AMENDMENTS TO THE DRAWINGS

Application No. 10/029,973
Applicant: Jeong Ho LEE et al.
Title: CHECK VALVE
Responsive to Official Communication dated: May 6, 2003
Confirmation No. 5445
Attorney Docket No. P21833
REPLACEMENT SHEET

FIG. 1
RELATED ART

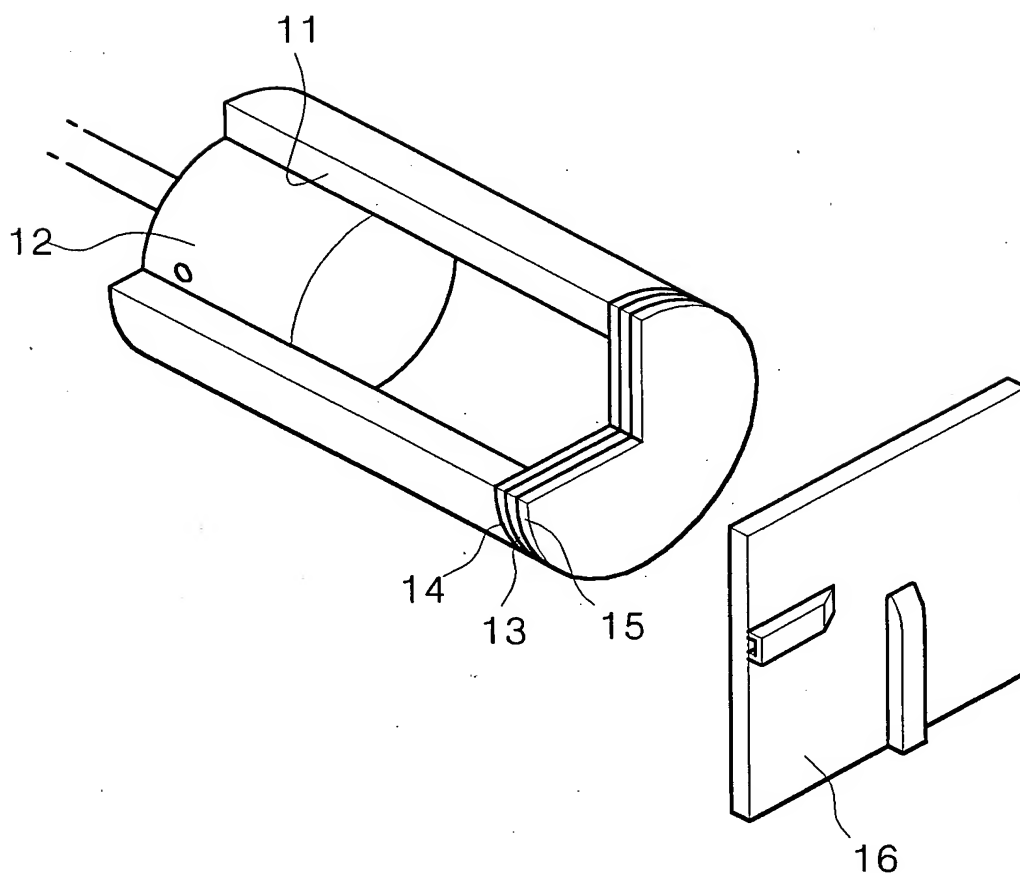
Please replace the three original sheets of drawings containing Figures 1, 2A-2D, 3A and 3B with the three replacement sheets of drawings attached hereto. In the three replacement sheets of drawings, Figures 1, 2A-2D, 3A and 3B have been labeled as "RELATED ART".

Not approved
RK
11/04/03
